Engine Coolant Leaks on 2000-02 Nissan 3.3L VG33E Engines

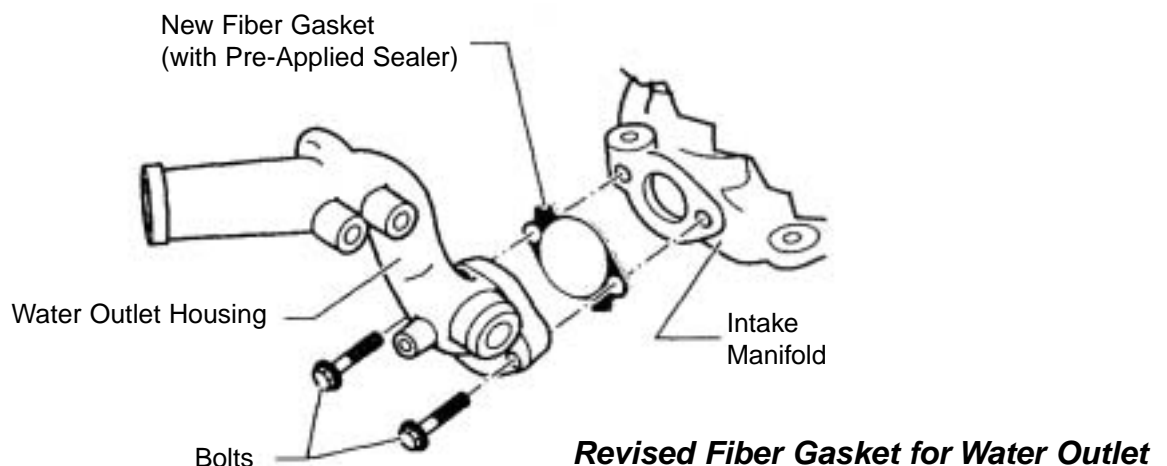
A leak between the intake manifold and the water outlet housing as shown below may cause this condition. Visually inspecting this area could verify that this is the source of the leak.

To rectify this problem, Nissan offers a revised fiber gasket, Part #11062-9Z000, to be installed between the water outlet and the intake manifold. When changing this gasket, make sure that you have drained the coolant just below the level of the water outlet. This will keep coolant from spilling when removing the housing.

Clean the sealing surface of the water outlet housing and the intake manifold to get rid of any old sealer that may be present. Install the two mounting bolts through the outlet housing and then slide the fiber gasket over the bolts until it is flush with the sealing surface of the housing.

Once the housing is installed onto the intake manifold, tighten the mounting bolts to a torque of 12-15 ft/lbs. Refill the cooling system and run the vehicle to verify that there are no further coolant leaks.
